# CITY OF ALBUQUERQUE

PLANNING DEPARTMENT – Development Review Services

Re: New Day Expansion – 2820 Ridgecrest S.E.  
Request for Permanent C.O. – **Accepted**  
Engineer's Stamp dated: 02-07-2013  
Certification dated: 10-29-13

**M18/D014**

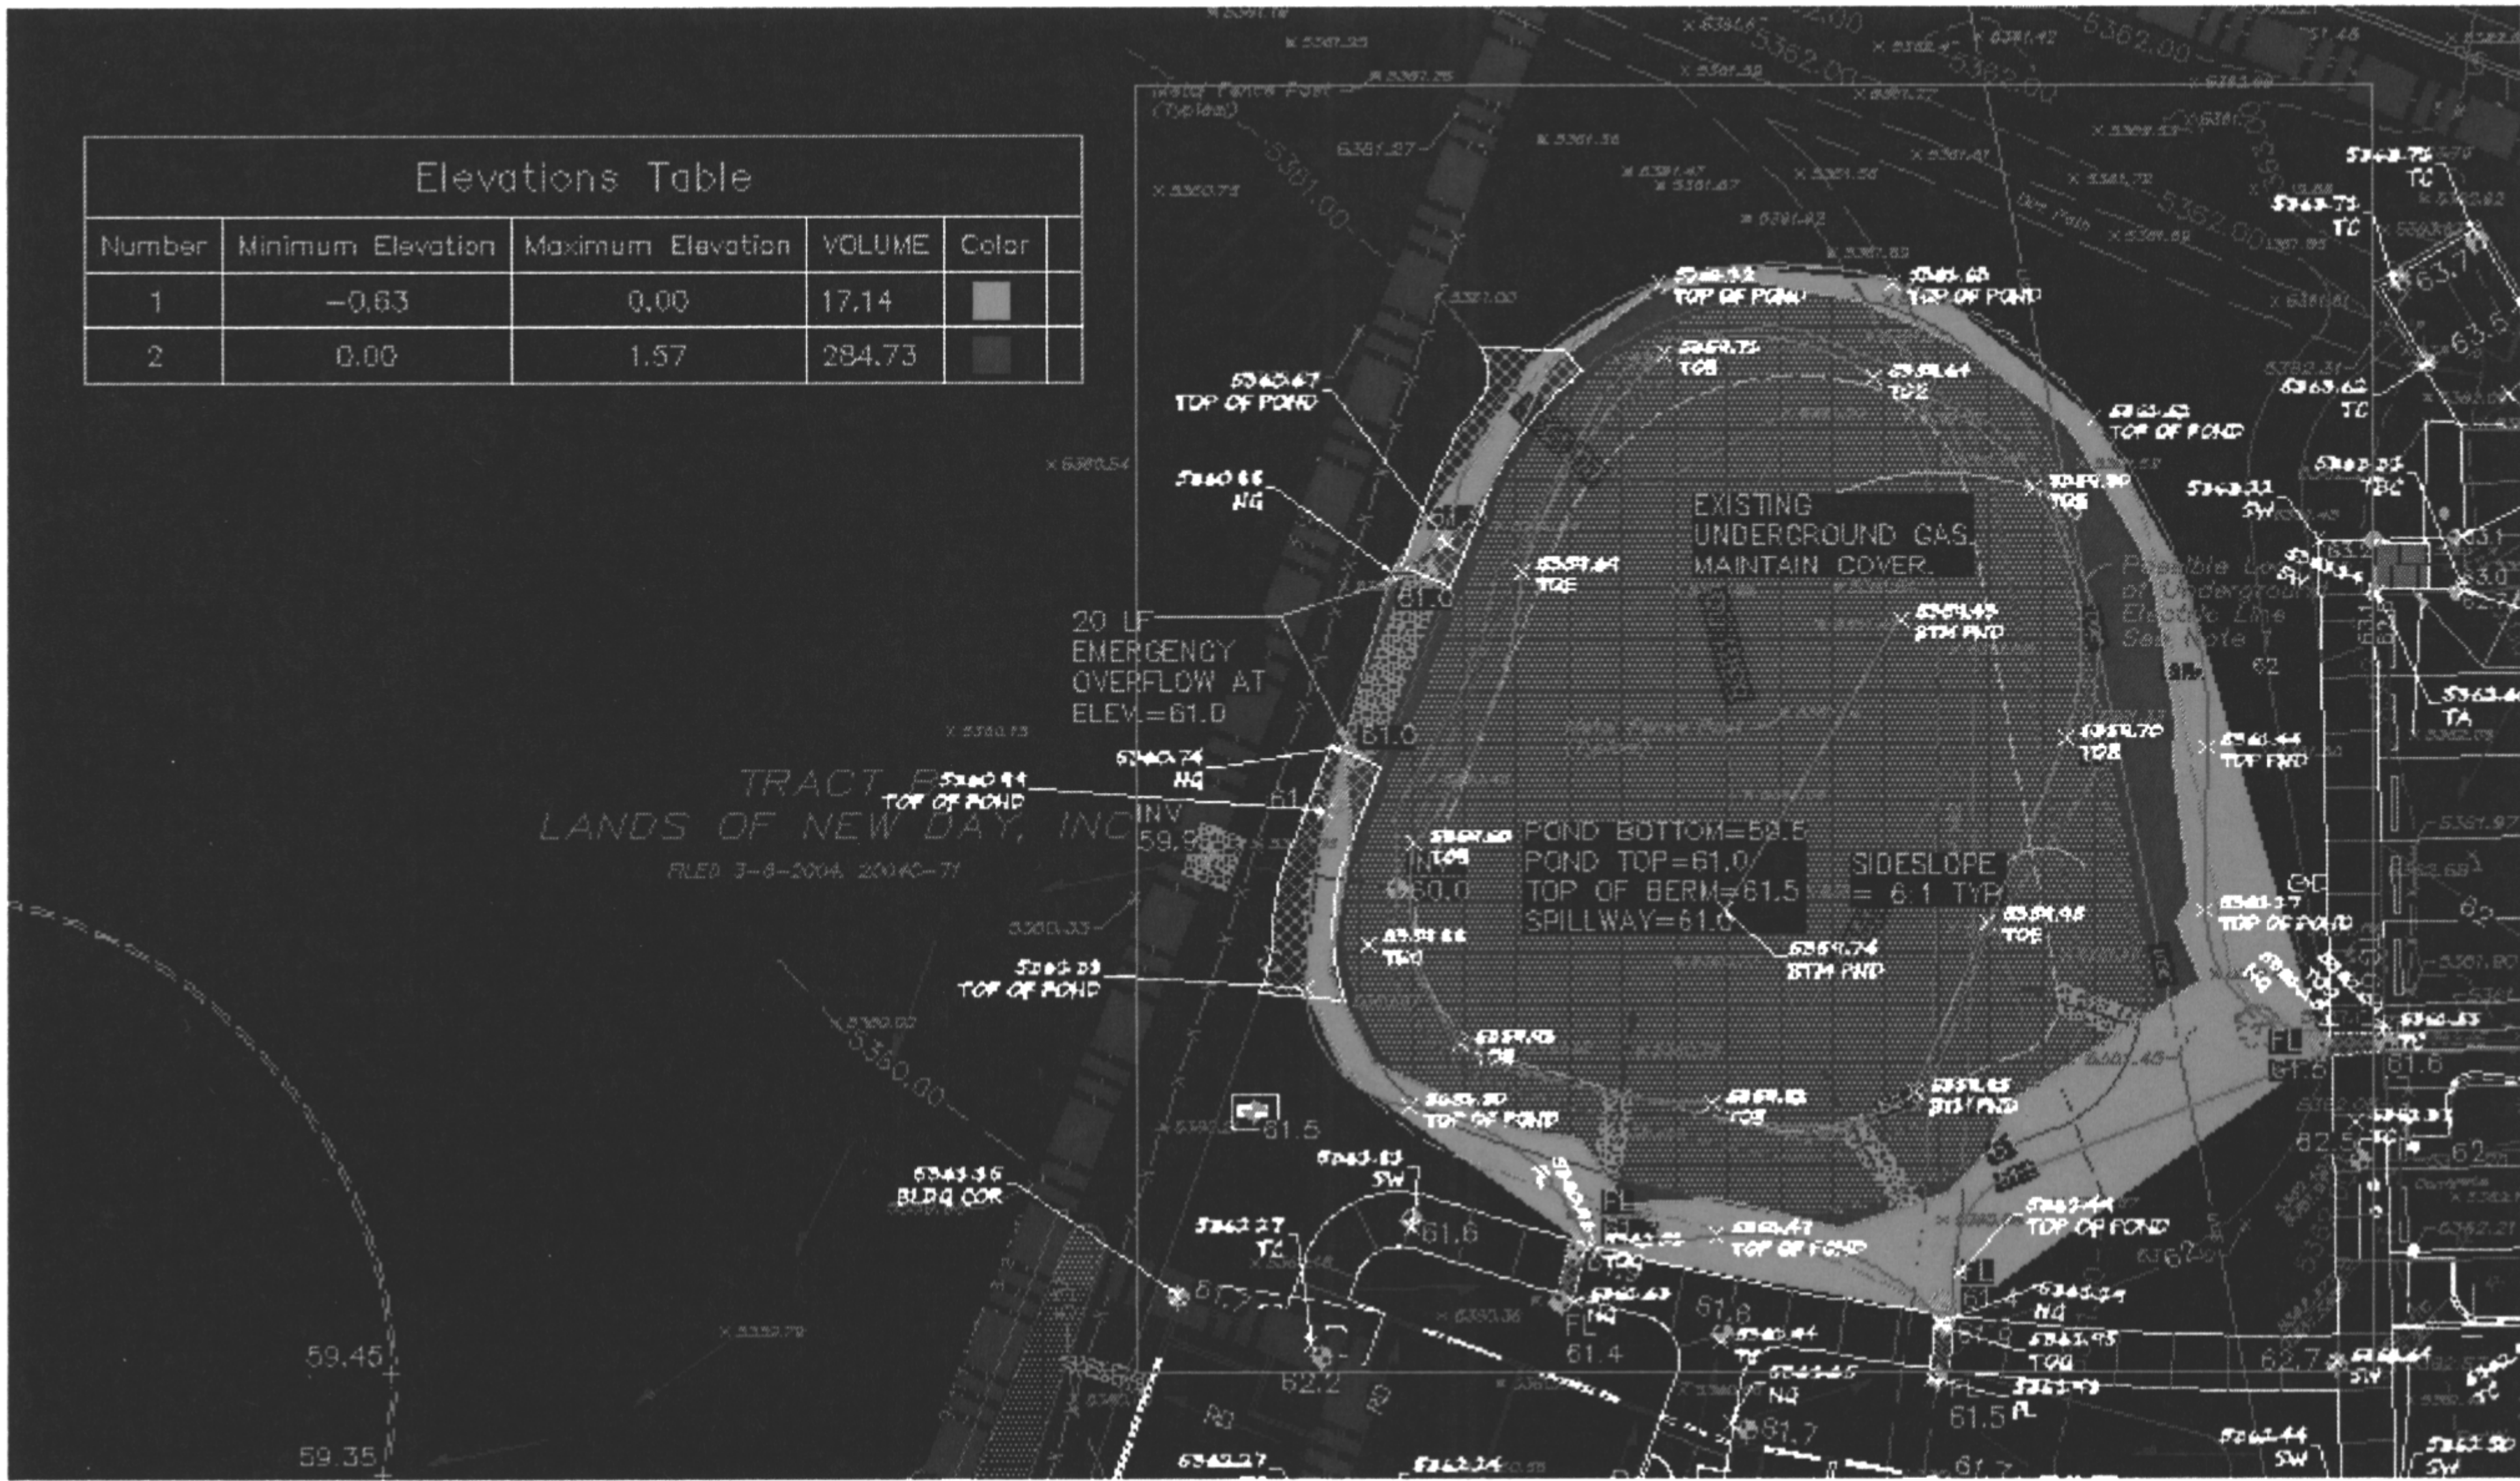
Based on Civil 3D volume analysis using the as-built information provided by the surveyor, the as-built pond volume with a spillway elevation of 61.0 has an available volume of 285 CY = 7,695 CF (see image below) which exceeds the required volume.

The as-built pond has been constructed with a volume exceeding the required volume. In addition, excess volume is available for future construction. It should be noted that Basin 2 for this phase of construction, generates 6,203 CF. The pond design did not take into account the inflow / outflow hydrograph (0.8 cfs discharge rate from the pond).
